Product Change Notice (PCN)

PCN Number: **PCN-0450952R-01**

Product(s) Affected: **PJ-025**

| PREVIOUS CUI DEVICES DETAIL / IMAGE | | | NEW CUI DEVICES DETAIL / IMAGE | | |

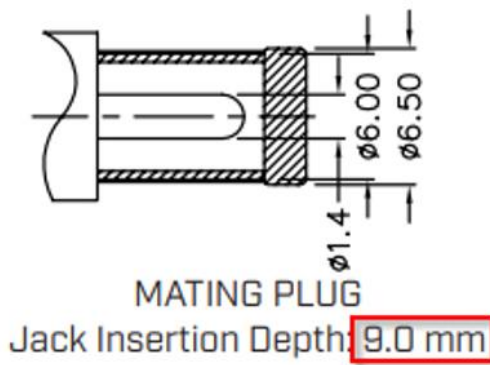
Description of Change: **Minor Housing and footprint differences. Material Change on the housing and terminals. See image Below**

| PREVIOUS CUI DEVICES DETAIL / IMAGE | | | NEW CUI DEVICES DETAIL / IMAGE | | |
|-------------------------------------|--------------|---------|--------------------------------|----------------|--------|
| | MATERIAL | PLATING | | | |
| center pin | brass | tin | terminal 1 | bronze t=0.50 | silver |
| terminal 1 | brass | tin | terminal 2 | bronze t=0.25 | silver |
| terminal 2 | copper alloy | tin | terminal 3 | brass t=0.40 | silver |
| terminal 3 | brass | tin | insulator | PA66 [UL94V-0] | black |
| plastic | PBT | | | | |
